STAFF RECOMMENDATION

NCPC File No. 7110

THE NATIONAL MALL TURF RECONSTRUCTION ON THREE EASTERNMOST CENTER PANELS

May 27, 2010

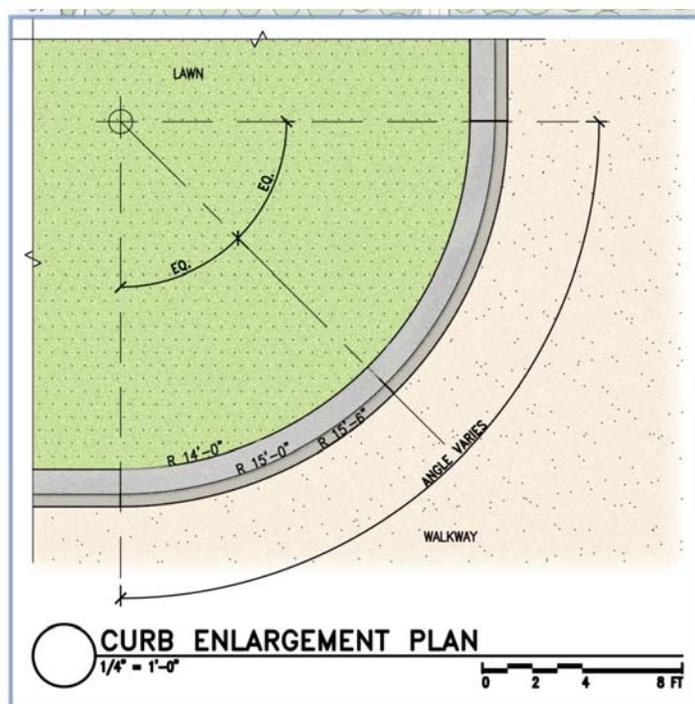
NPS proposes White Mount Airy granite with a flame finish for the curb and gutter. A second choice is precast concrete. Staff strongly recommends the use of granite. Fifteen-foot curb radii are proposed for the corners of the lawn panels, which would return the curb radii to the dimension in use on the Mall from the 1930s--when Frederick Law Olmsted, Jr. implemented the McMillan Plan--until the 1970s, when Skidmore, Owens, and Merrill redesigned the roads and paths on the National Mall by, in part, filling the east-west street beds with gravel.

NPS recommends the 15-foot curb radii in part to restore the earlier appearance of the lawn panels, but also as a method of minimizing the compaction of the soil in the lawn panels and the deterioration and loss of turf at the corners, a typical and unsightly condition with the current gravel paths. In addition, gravel migrates to the lawn panels and soil migrates to the paths. Rainwater ponds at the edges of the gravel paths because it does not drain adequately.

Below are a current photograph of the edge of a center lawn panel showing an irregular turf edge and ponding of rain water (“before”) and a rendering of the panel with the curb and gutter (“after”).

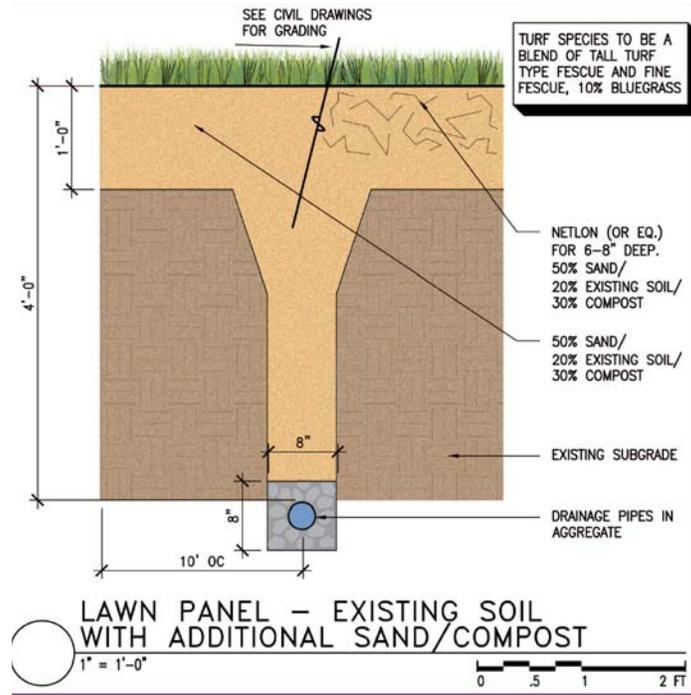
The subject of most discussion, and the visible alteration in this project, is the installation of a low curb and gutter around the perimeter of the center lawn panels. Staff recommends that granite be used. The vertical height of the "curb" will be imperceptible to the eye, but the 18-inch width of the curb and gutter will be a change from the current condition. The SOM scheme, as planned, had 90-degree corners where the lawn panels met the gravel paths. The corners soon deteriorated, however, due to visitors and vehicles crossing them, and it has become difficult if not impossible for NPS to re-sod and maintain the corners. The gravel has migrated into the grass panels not only at the corners but along the edges, so that it is difficult to discern the true edges of the panels.

The 15-foot radius dimension is one of several aspects of the design that will require further consultation as the design is developed. The dimension is consistent with the curbs in use on the Mall from the 1930s to the 1970s. Staff would like to ensure through further discussion with NPS and study on site that the radius remains appropriate for the lawn panels now that the streets have been converted to pedestrian paths.

Recommends that the curb be constructed of granite and **notes** that NPS will continue consultation on the dimension of the curb radius as the design is developed further.
